HISTORIC PRESERVATION REVIEW BOARD STAFF REPORT AND RECOMMENDATION

Landmark/District: Address:	Episcopal Home for Children 5901 Utah Avenue NW	(x) Agenda
Meeting Date: Case Number:	August 3, 2023 23-431	(x) Alteration(x) Permit

Fencing

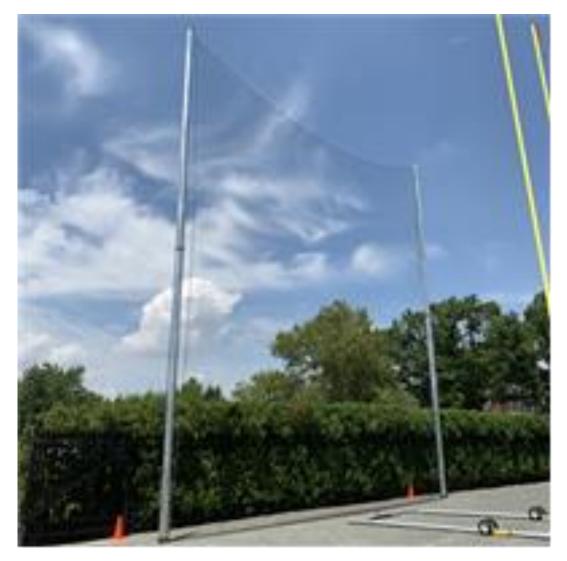
The principal issue on the landmark site is the installation of fences to separate the zone used by Maret from the Episcopal Center. As the proposed fencing only partly follows the landmark boundary, the fences cut into the designated area. While the Board may set a landmark boundary or allow a subdivision that divides the ownership of a landmark, it typically wishes to minimize the feeling of physical separation of parts within a landmarked parcel.

It is true that the sections of fence separating the two A&T lots would be four feet tall, only six inches taller than is ordinarily approved for front-yard fences. The sections dividing the property from neighbors would be six feet tall, one footer shorter than generally allowed. The metal fencing is characterized as "ornamental," although it lacks much ornament; it is a tubular-metal

fencing with C-channel rails and bracket connections, a type discouraged in front yards, but acceptable at the rear of a landmark property. The landscape plans indicate planted borders on the fieldhouse side of the fence, but such plantings may be more appropriate and useful softening the view from the opposite side.

A gate or gates would be erected to admit a vehicle from the alley north of the property. The civil drawings show this as swing gates, presumably of chain link, while the landscape drawings portray it as sliding and similar to the design of the fence. The civil drawings also indicate that the length of the six-foot perimeter fence along the rear of 5931 Utah Avenue would be "opaque," but it is not clear about how an open, metal fence is also to be solid. All such issues should be resolved; anything shown on the civil plans could be presumed approved by clearance of the permit. Thus, everything should be detailed prior to issuance.

One corner of the soccer field would cross the landmark boundary, and it would be surrounded by a six-foot-tall chain-link fence. A much taller feature would be the netting supported by aluminum poles, similar to those below, but in a black finish. The project team says that those within the landmark and behind home plate would be 30 feet tall, but some elsewhere would be 20 feet.

HPO seeks the Board's direction on the project, especially with regard to the proposed barriers. Fencing to separate the fieldhouse seems unnecessary, yet it is only four feet high and would surround a noncontributing building at the rear corner of the property, so the visual effects are limited. The poles with netting that bound the soccer field have a greater visual effect, but they, too, are on a rear corner of the property.
